CITY OF ALBUQUERQUE

**RE: Custom Home – 1020 Atrisco Dr NW
99999 Atrisco Dr NW
Grading and Drainage Plan
Engineer's Stamp Date: 12/08/25
Hydrology File: J11D050
Case # HYDR-2025-00461**

Based upon the information provided in your submittal received 12/30/2025, the Grading & Drainage Plans **are not approved** for Grading Permit or Building Permit. The following comments need to be addressed for the approval of the above referenced project.

**GRADING &
DRAINAGE
PLAN**

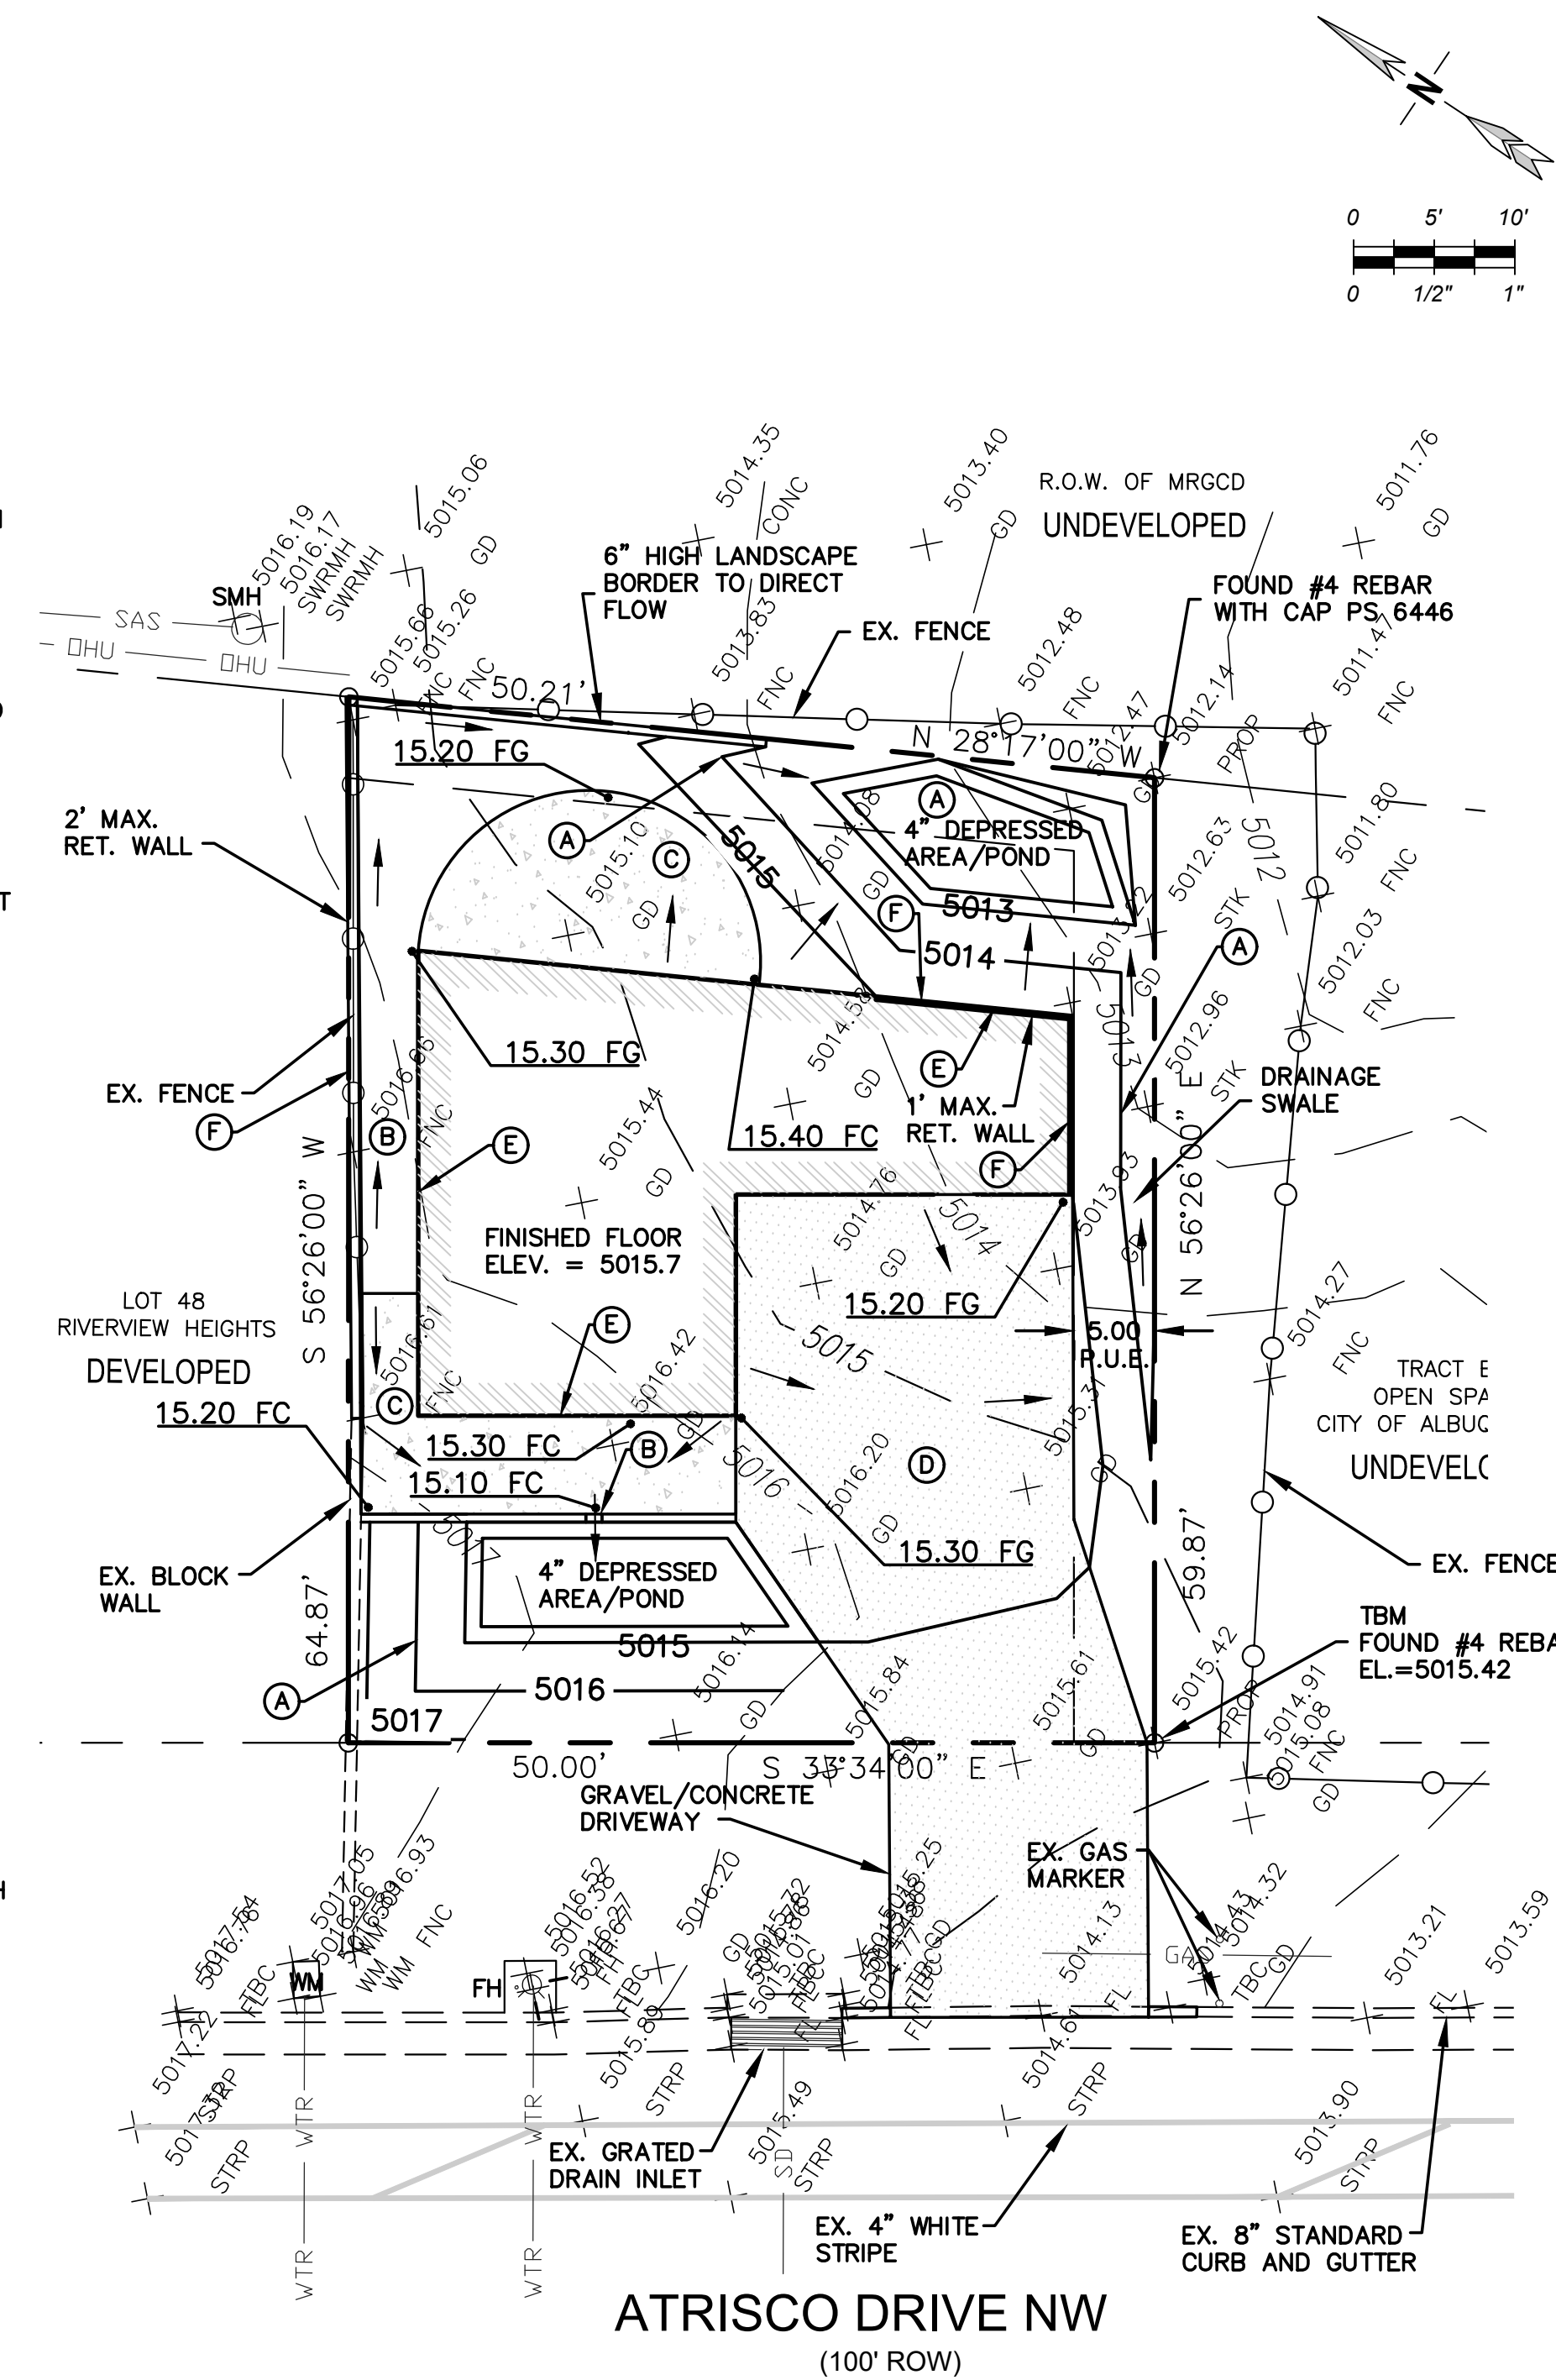
1. Per the IDO, the property owner of the property is responsible for building the adjacent half of Atrisco Drive NW to include curb & gutter, **and sidewalk**. The project will have to go to the Development Facilitation Team (DFT) for approval of the Infrastructure List. Please show the sidewalk on the plan.
2. Provide the existing and proposed grades on both sides of the proposed retaining wall.
3. Provide sections through all external boundaries showing proposed retaining walls, garden walls, property/ROW lines, existing and proposed grades. In accordance with DPM Ch.22, section 5 part B, grading and wall construction near the property line may not endanger adjacent property or constrain its use
